Limited Visual Dam Safety Inspection Summary Report

MA-132

Puukoa Reservoir

Limited Visual Dam Safety Inspection Conducted on: 07 April 2006

132 downstream slope

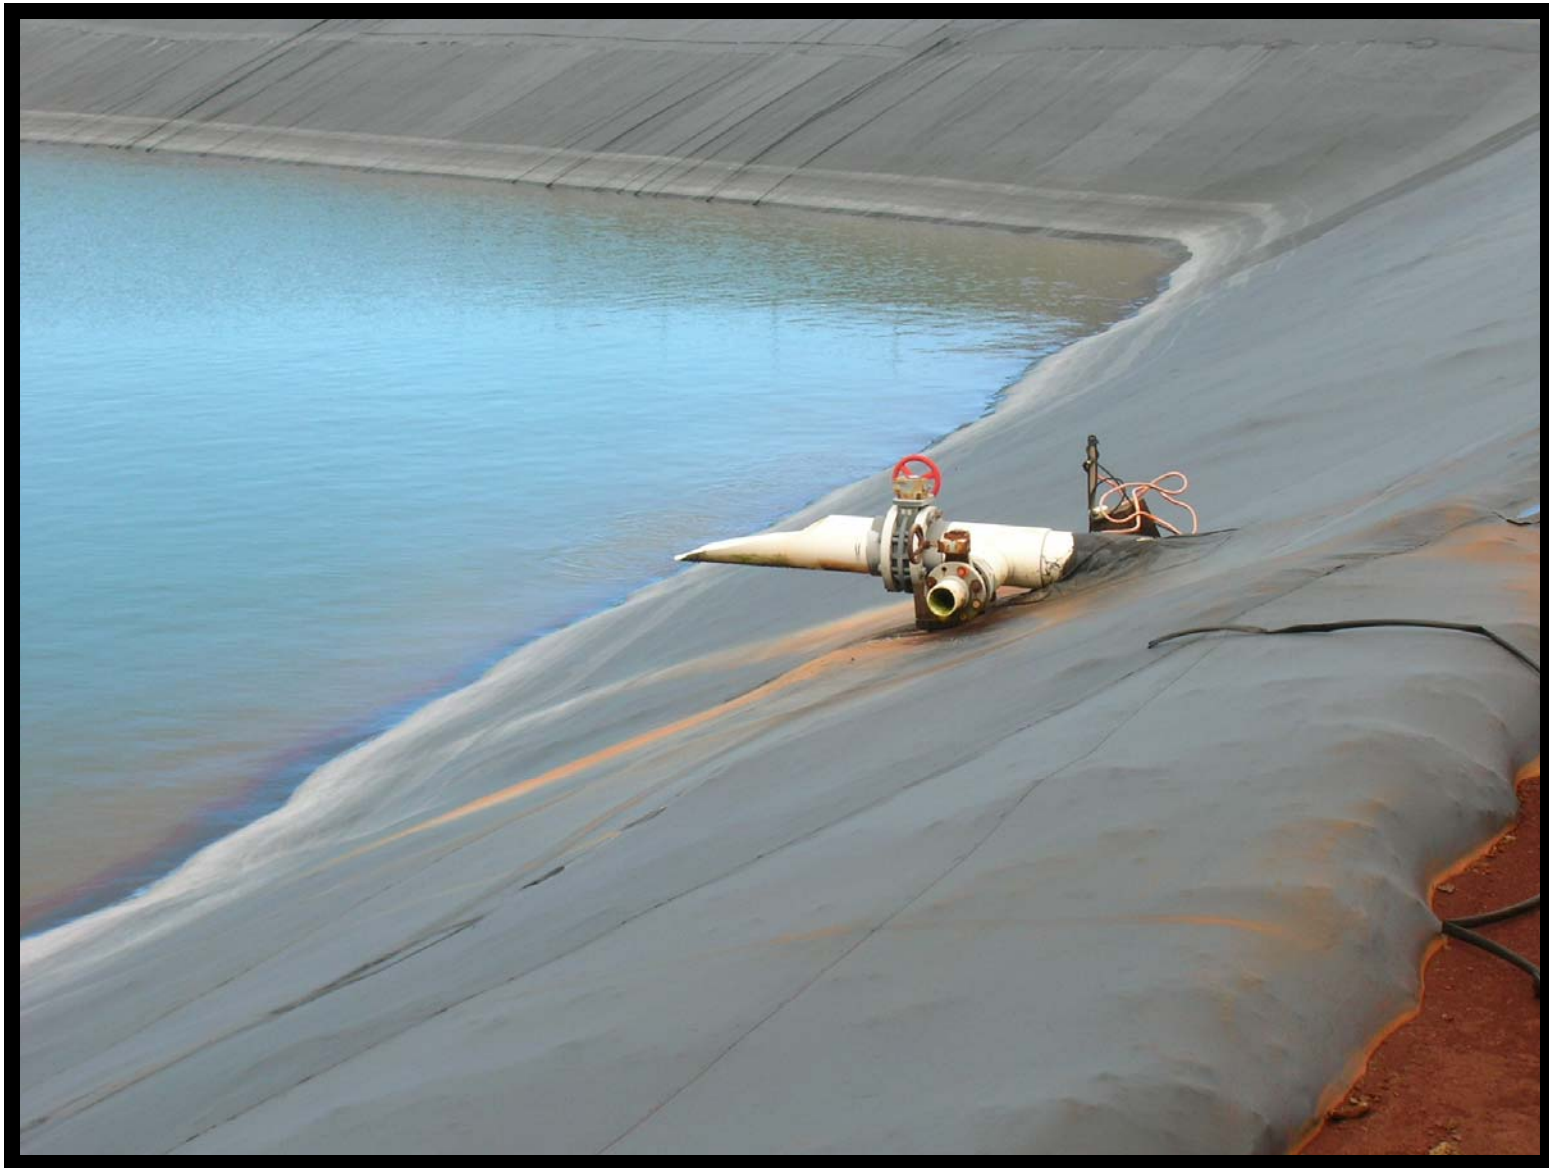
Several small erosion ruts were visible on the downstream slope.

Seepage was visible about half way up the downstream toe and was observed to be less than 0.5 gal/min. This seep dries up during dry periods.

- a. The downstream slope appeared to be in fair to poor condition and requires corrective action.
- b. Seepage/Ponding water was observed. Monitor and conduct further investigation to locate the source of water and extent of any possible hazardous or developing condition.
